<b>BW Project No.:</b>	24-12-247
<b>BW Project Title:</b>	DPW. 25269 UI Campus Drive Repairs, Phase 3
<b>Client:</b>	University of Idaho
<b>Date:</b>	04-23-2026
<b>Addendum #:</b>	002

This addendum consists of a total of 4 pages and 16 drawings.

# UI: CAMPUS DRIVE REPAIRS, PHASE 3 UNIVERSITY OF IDAHO

COVER &  
INDEX  
**G1.0**

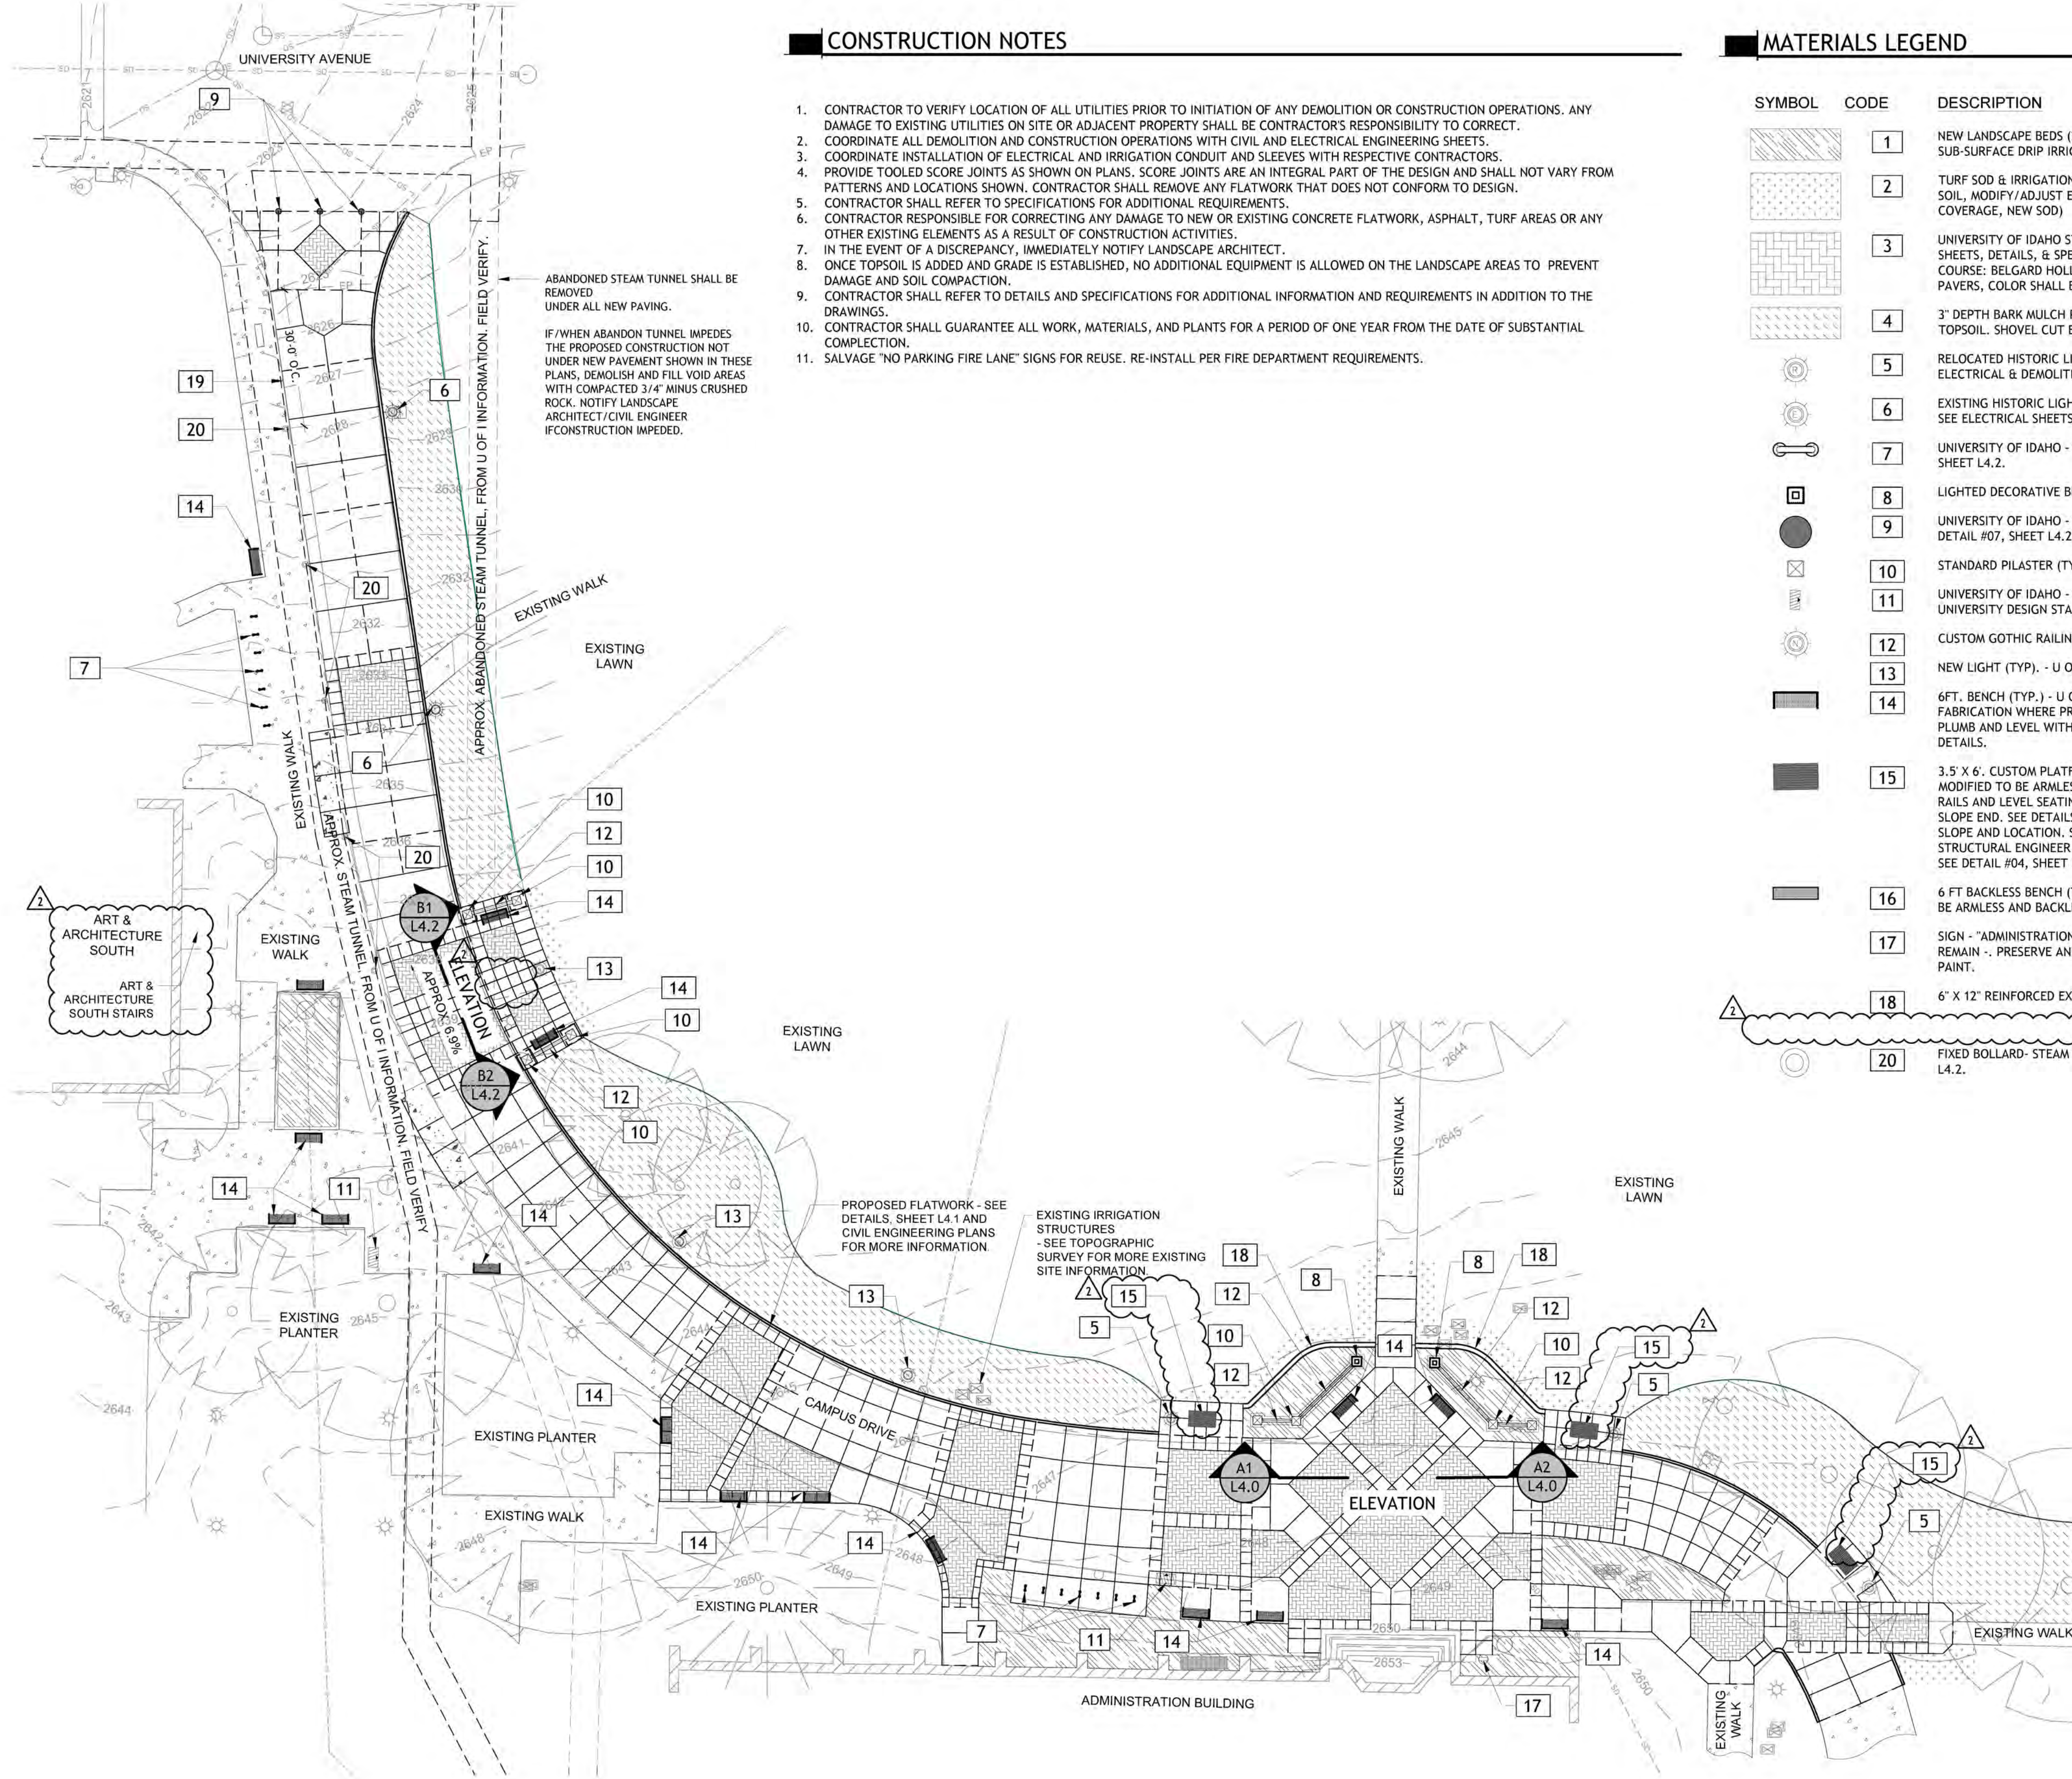
1. Sheet G1.0: Art and Architecture South label added. Administration Building label revised.
2. Sheet L1.0: Art and Architecture South label added. Art Architecture South Stairs label added. Administration Building label revised and for stairs. Remove reference to note 19 "RED CURB PAINT, SEE CIVIL SHEETS". 3x6 custom bench is removed from the AAS Plaza. Keynote has been relocated outside of the paver hatch. Bench types and sizes listed on sheet L1.0 shall prevail.
3. Sheet L2.0: Tree cultivar was replaced with a standard Norway Maple to match the existing trees
4. Sheet L2.1: Administration Building label added. Art and Architecture South label added. Art & Architecture South Stairs label added. Art & Architecture South Planter Plan & Planter Legend revised.

BULB  
ENLARGEMENT

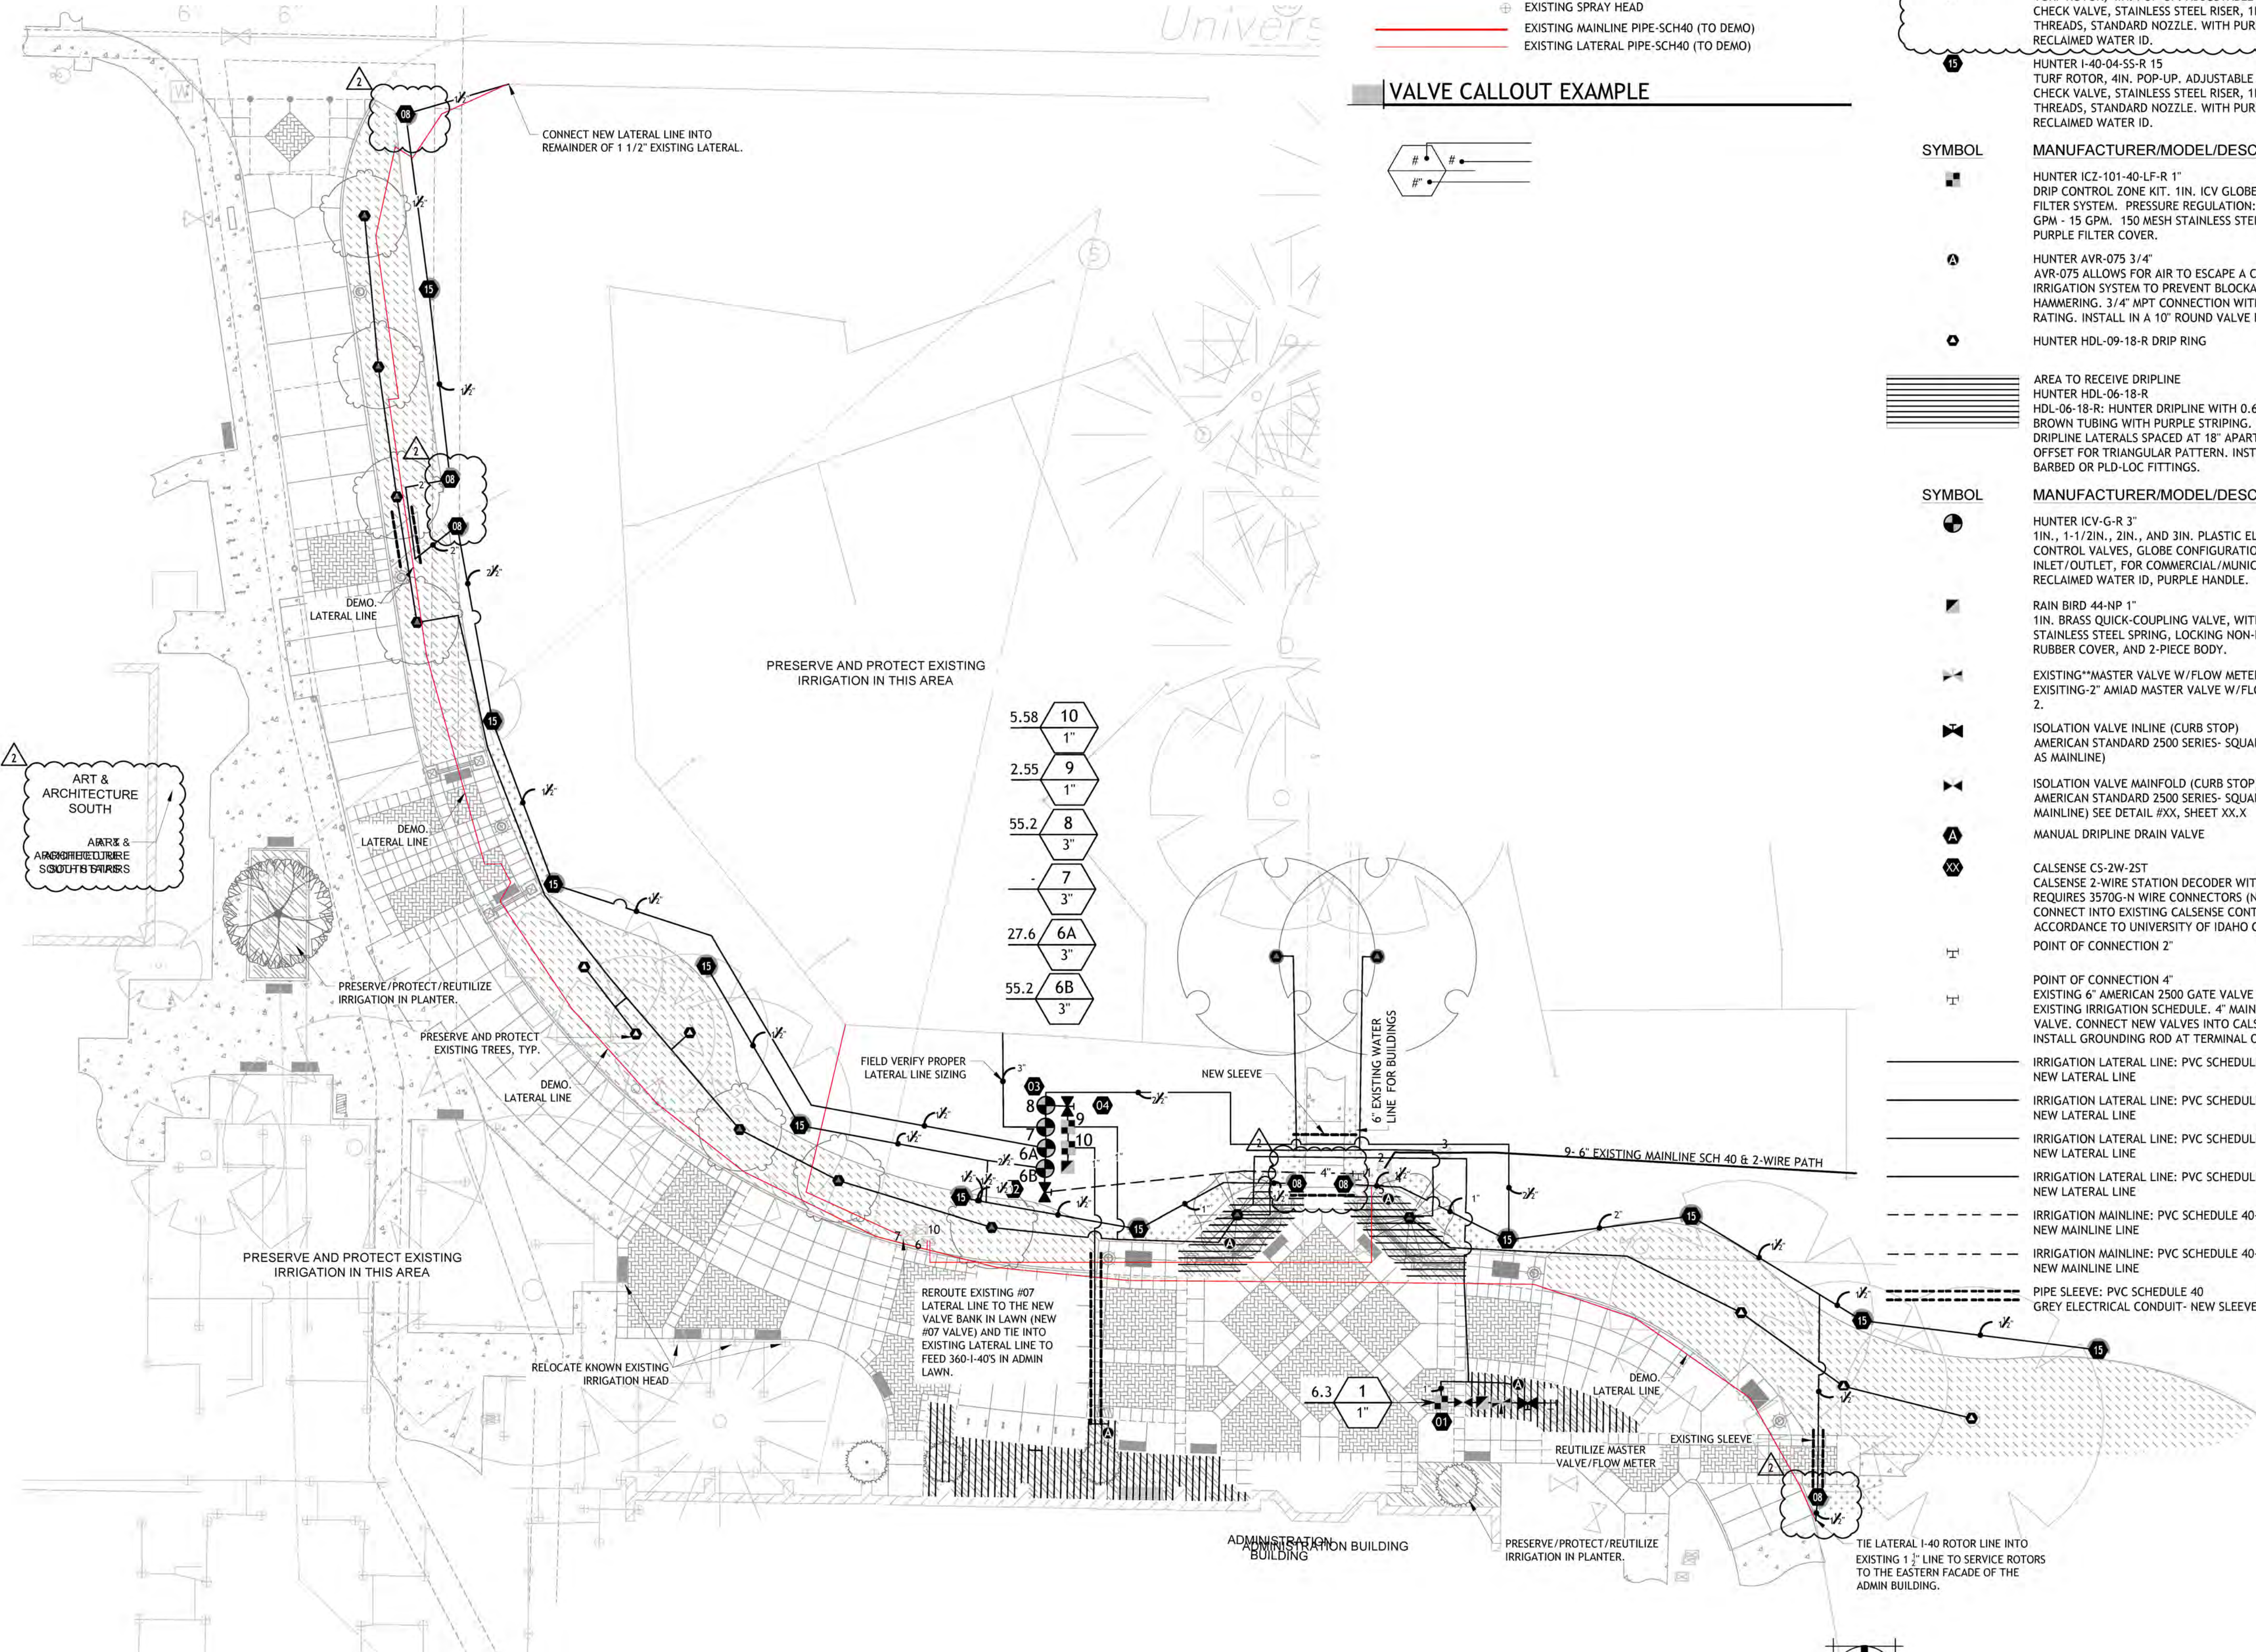
5. Sheet L2.2: Art & Architecture South Planter label added.
6. Sheet L3.0: Art & Architecture South Planter label added. Art & Architecture South Stairs label added. Sprinkler rotor nozzles revised at corners and added to irrigation schedule.

**01 B1-B2 ELEVATION - ART & ARCHITECTURE SOUTH PLAZA**

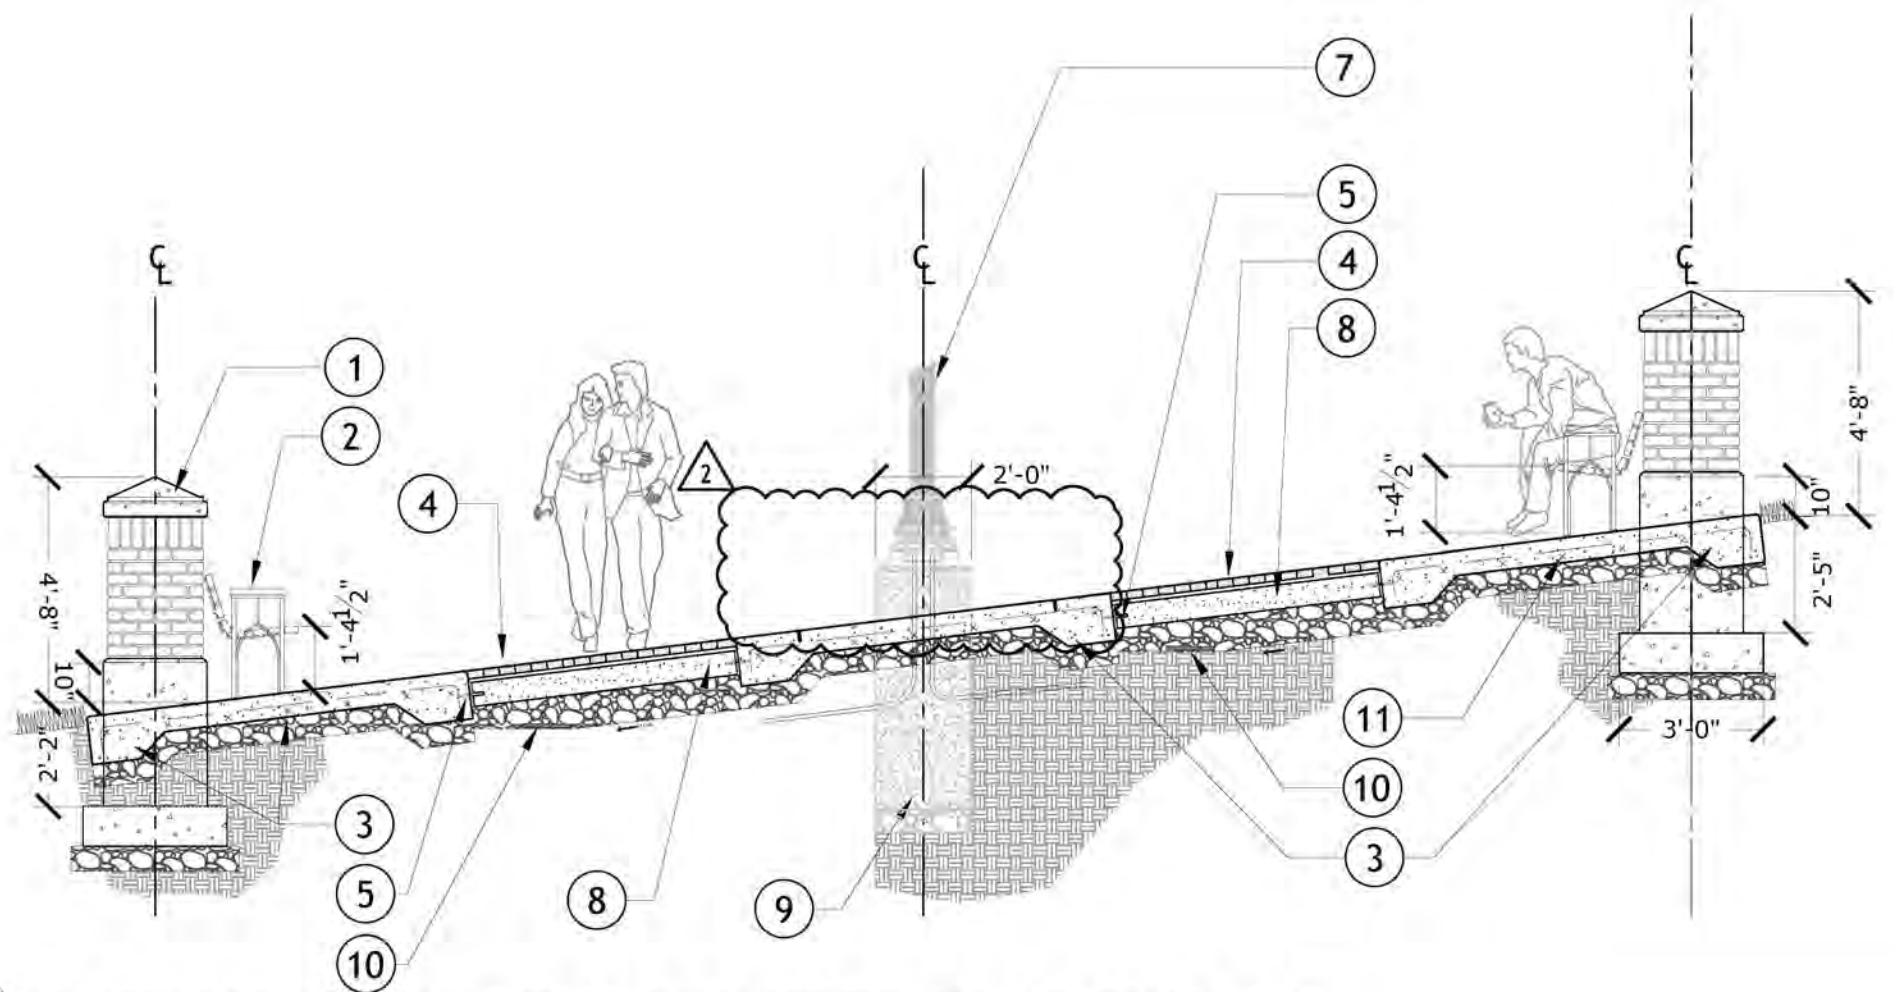
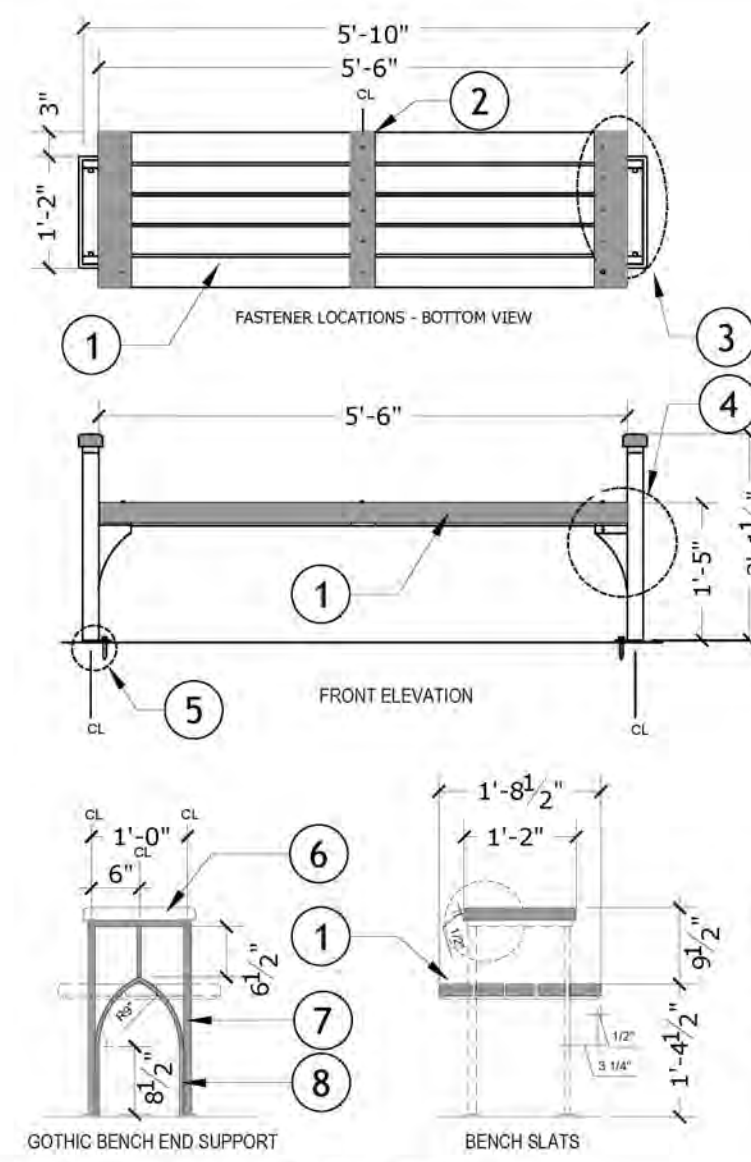
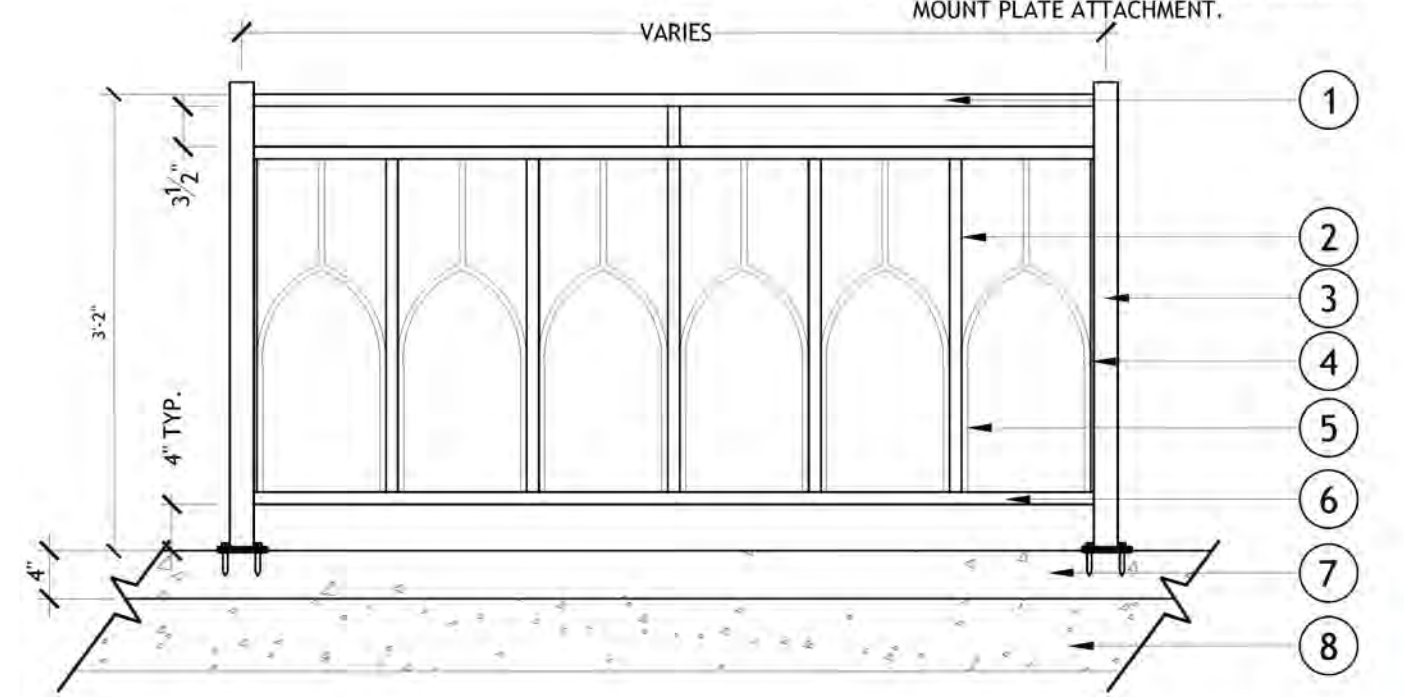
9. Sheet L4.2: 1/B1-B2 Detail has been renamed to reference Art & Architecture South Plaza. The backless bench has been removed.
10. Sheet C1.0: Tree protection fencing
